March 11, 2024

TO : All Bidders
FROM : Bob Lavey
PROJECT : Nogales High School New Building and Aquatic Center
Project W2110000AR.41
DSA : 03-122782 / File 19-92
SUBJECT : Addendum 3

DRAWING NUMBER: **EB2.1**

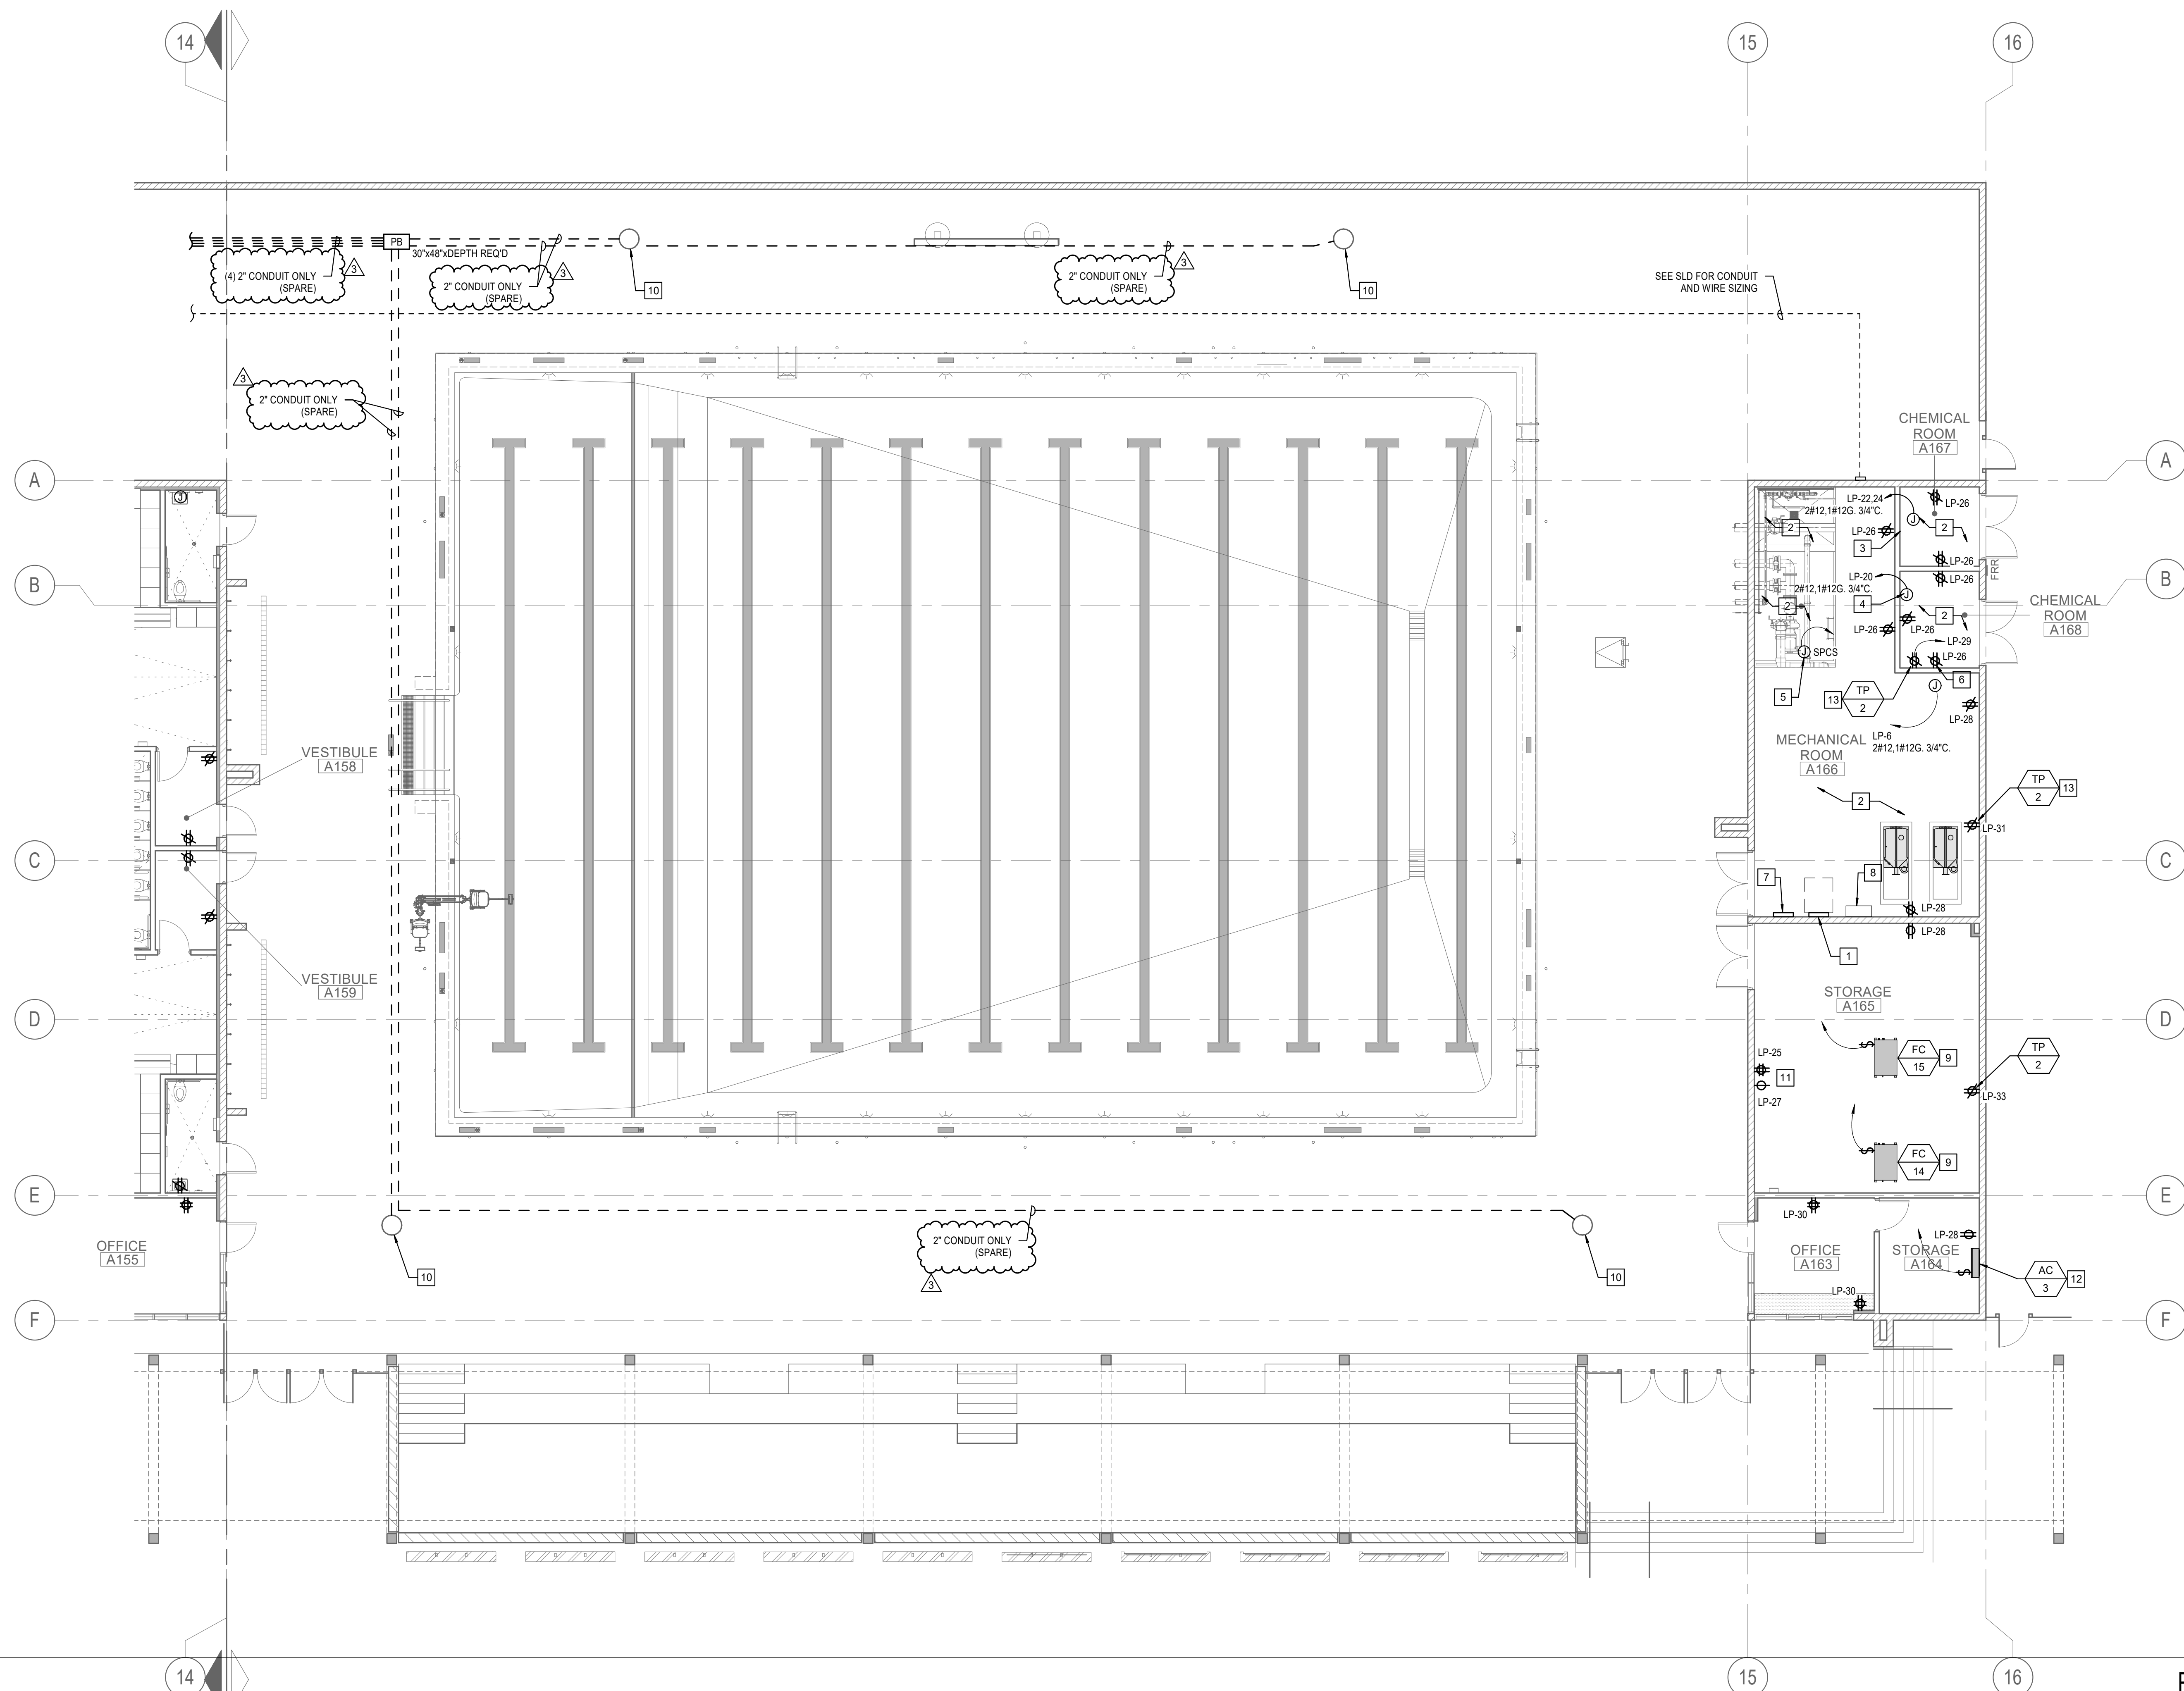
- A. Added notes for spare conduits to future Musco poles per the attached Drawing EB2.1.
- B. Added pullbox sizing per the attached Drawing EB2.1.

DRAWING NUMBER: **FA5.1**

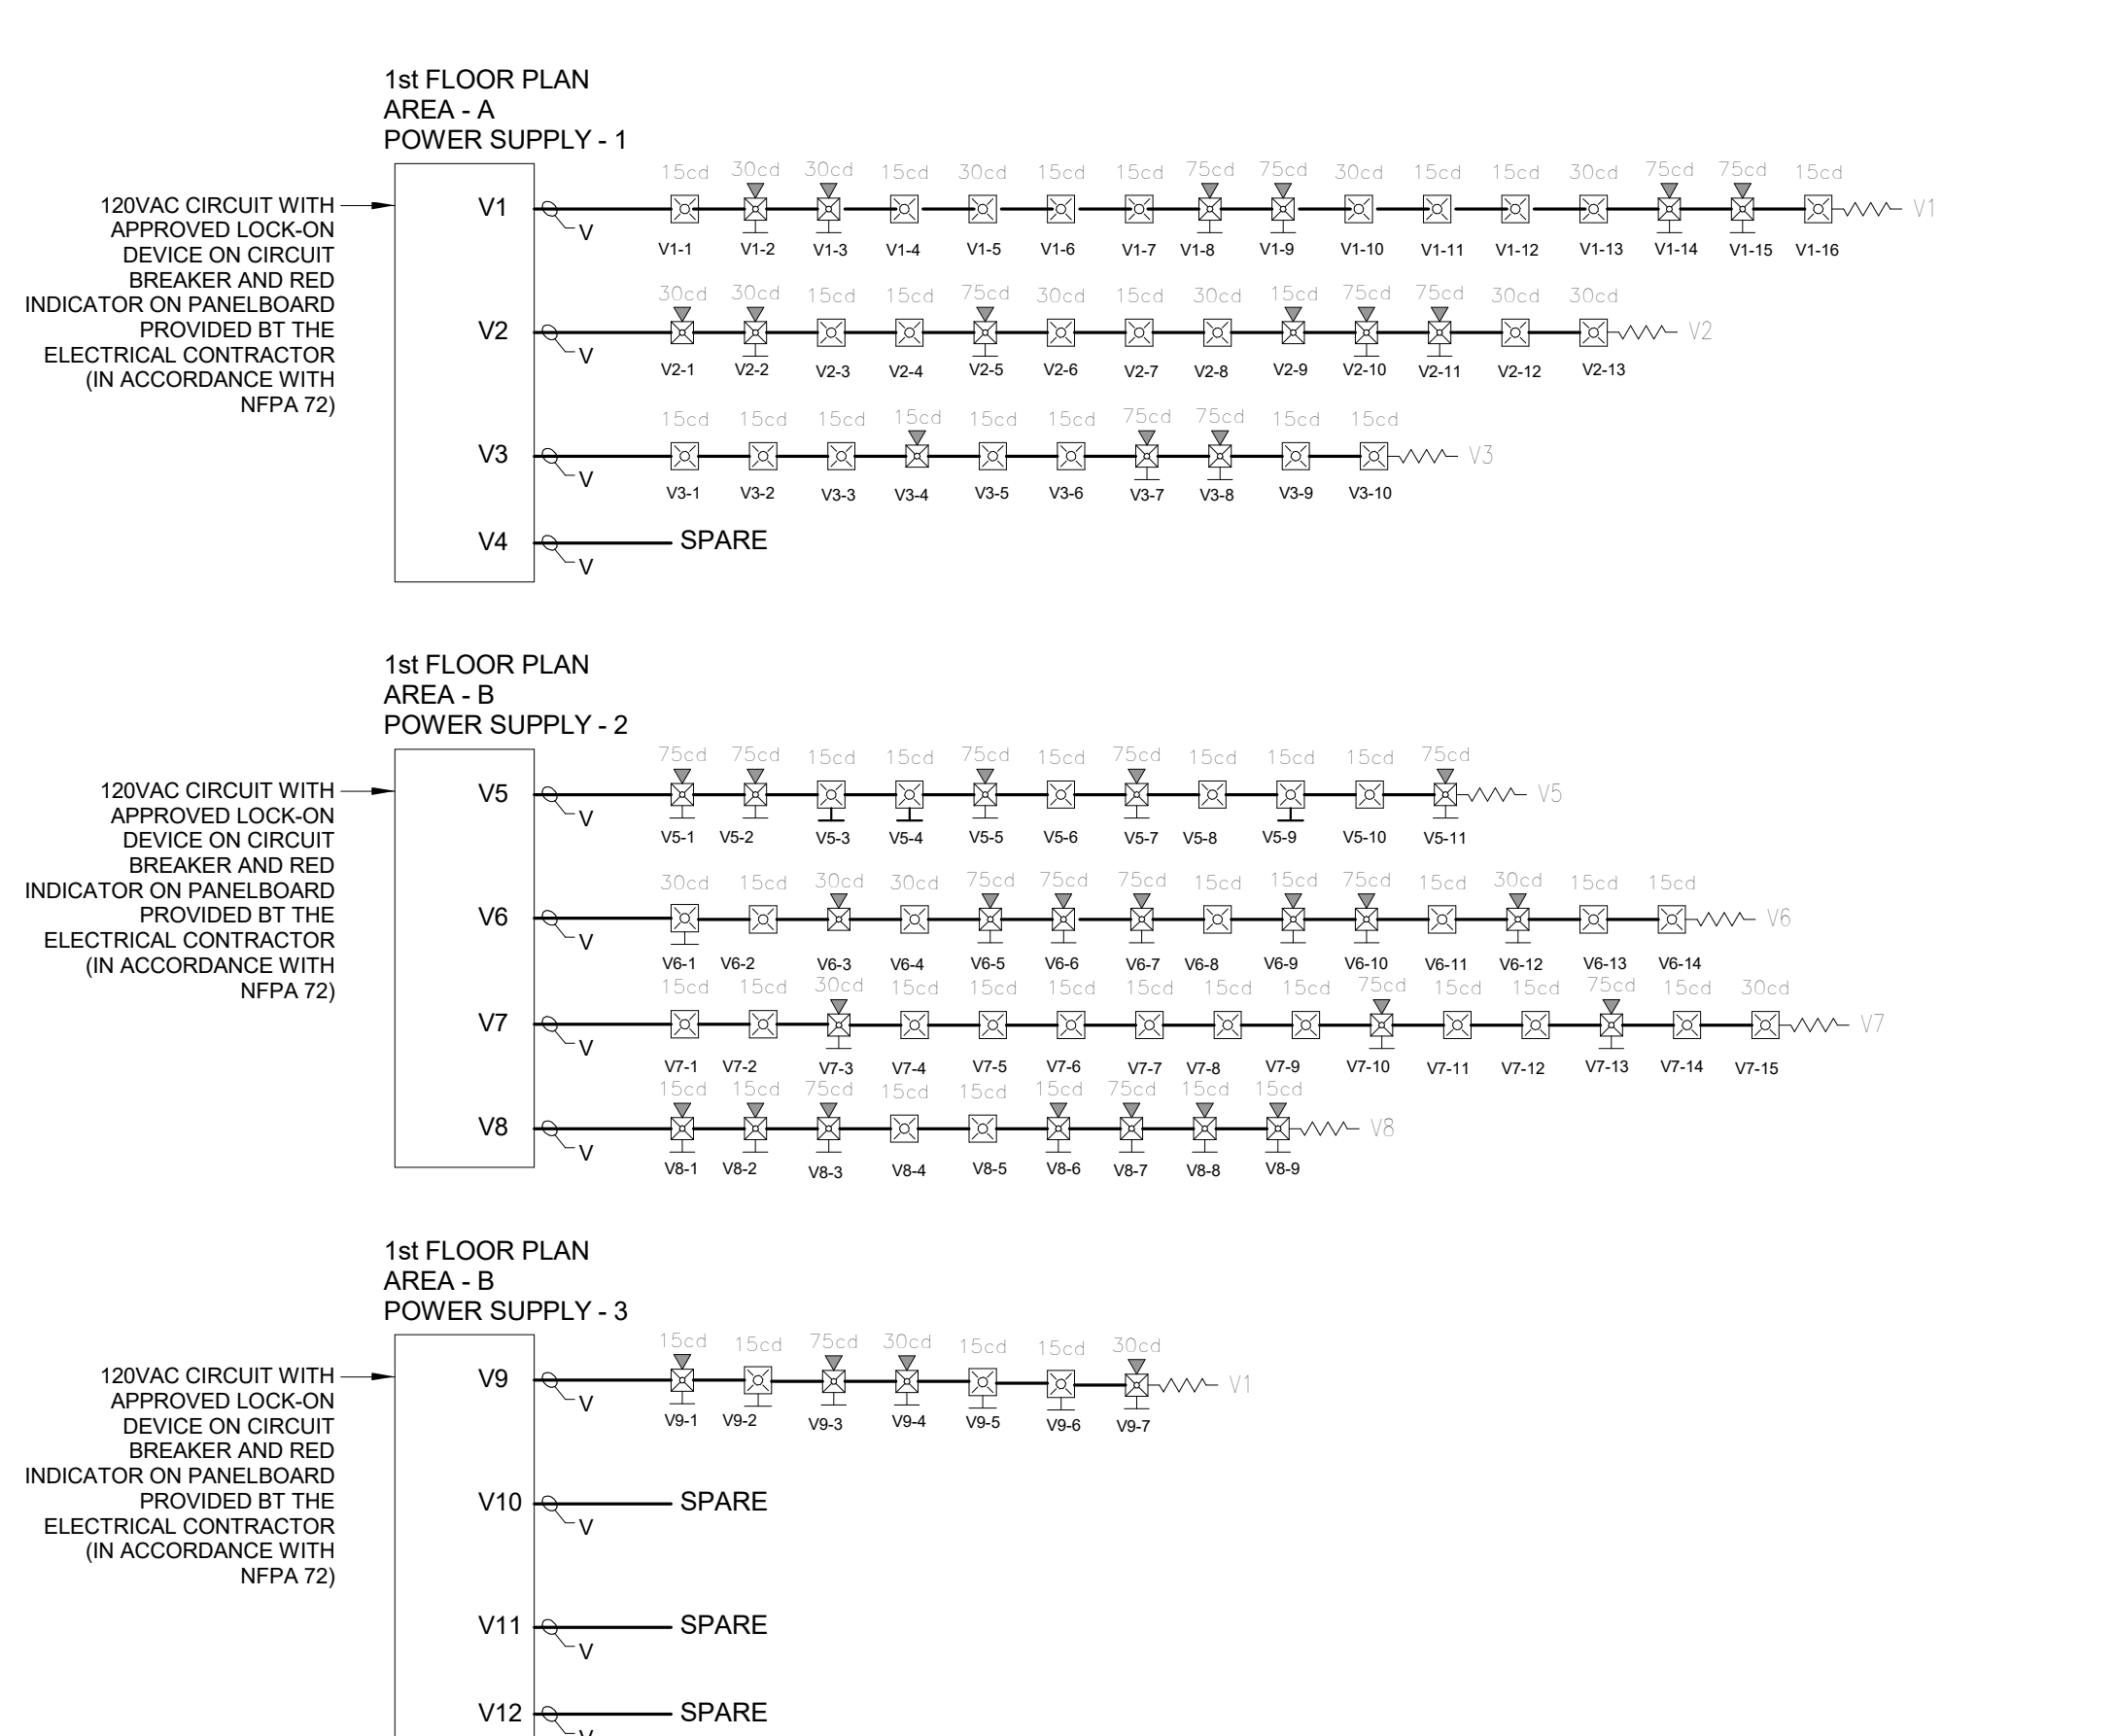
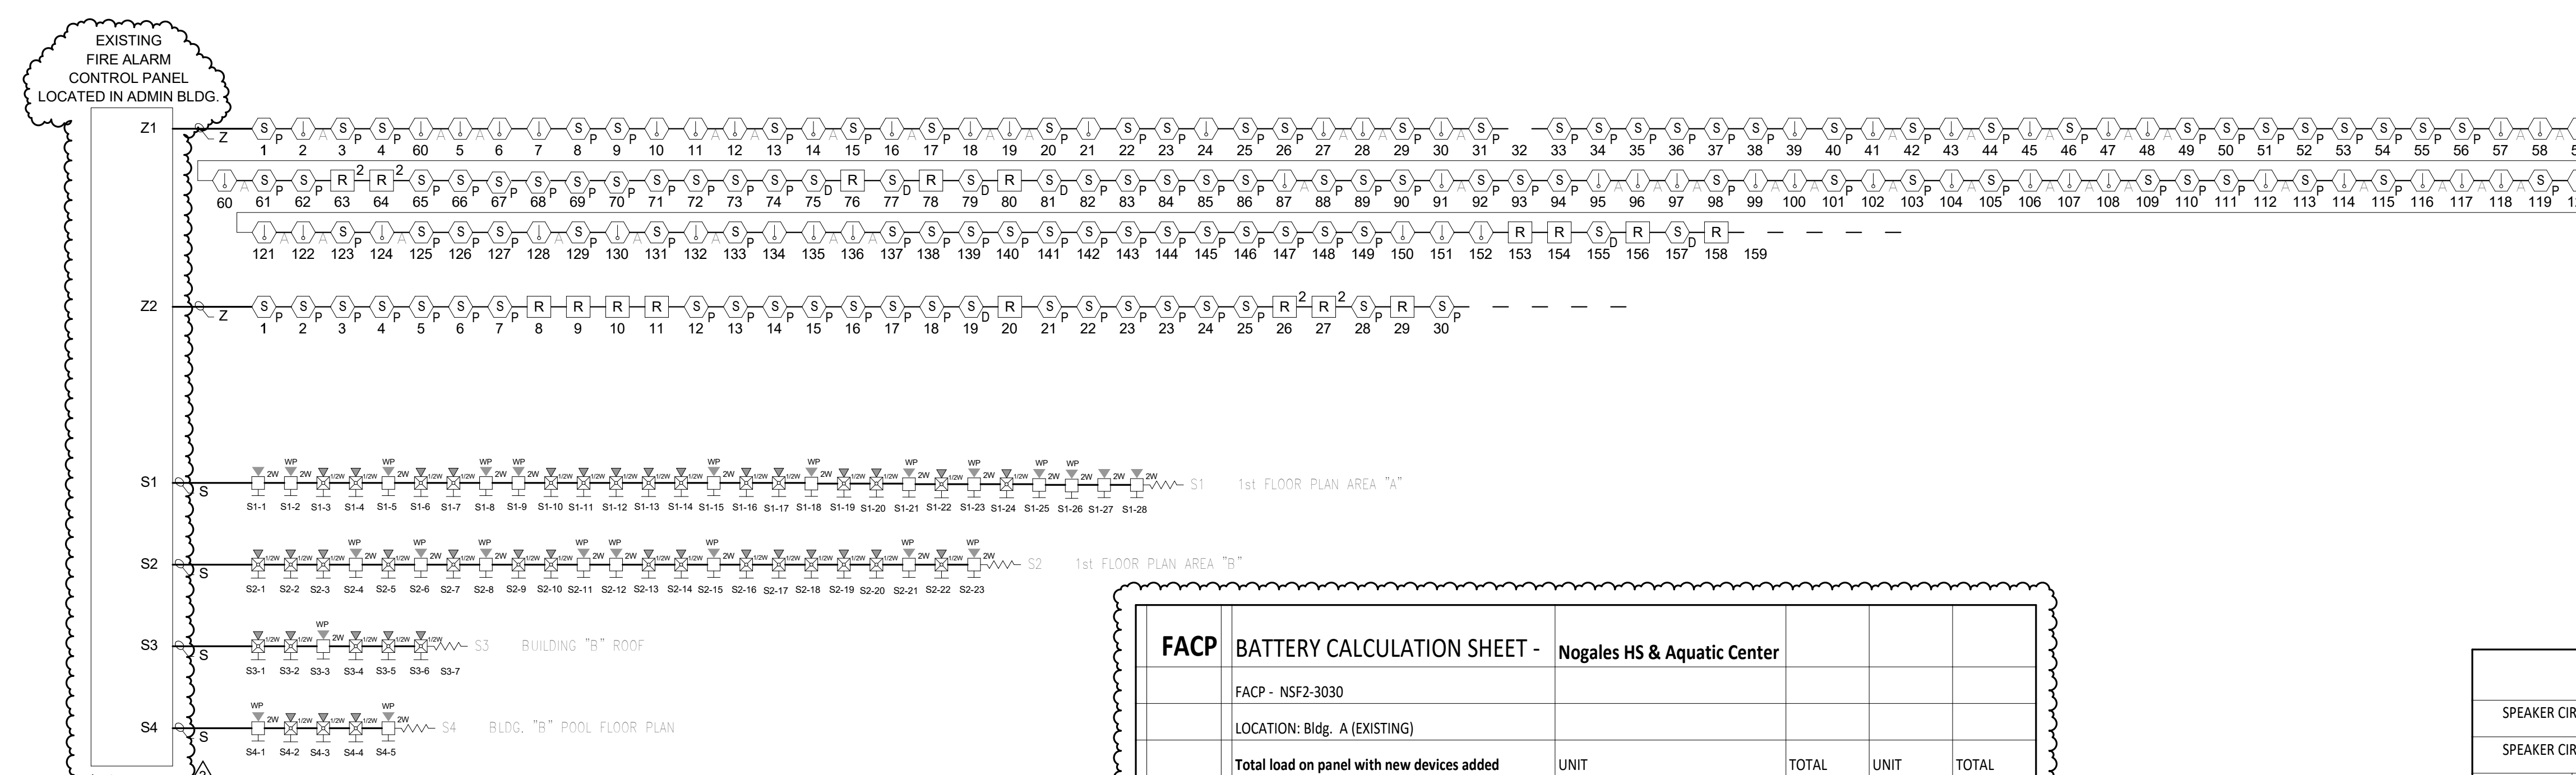
- A. Updated riser diagram and panel calculations per the attached Drawing FA5.1.
